Ein Cyf/Our Ref.: CH/07/0641/2-10/AE
Eich Cyf/Your Ref.:

**RE: ERECTION OF 2 DWELLINGS ON LAND OPPOSITE 1-6 CHAPEL STREET,
BEDLINOG**

I refer to the various details submitted to these offices on 4th and 15th February 2010 and 5th March 2010, in pursuance to the conditions forming part of planning consent 07/0641, regarding the above named development.

Railings

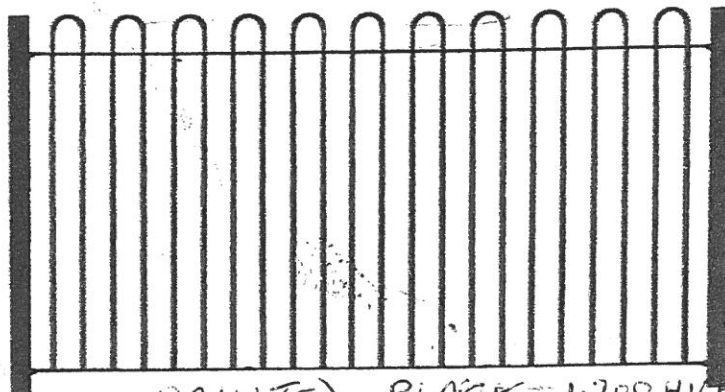
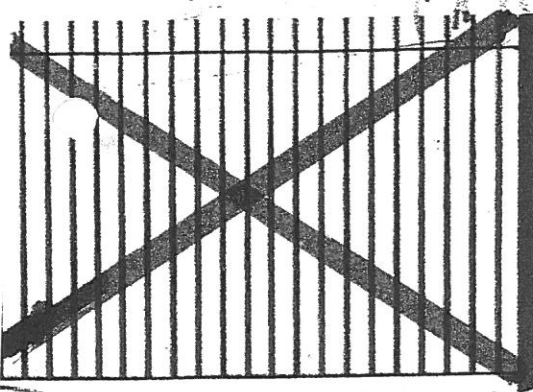
Furthermore, this drawing fails to provide elevation details of the proposed bow-top fencing to Chapel Street. Neither has its colour

been specified, nor its specific height (your letter only indicates that it will 1.2m-1.4m in height).

However, the information contained in the drawings and brochure extracts submitted to these offices on 5th March 2010 is considered acceptable.
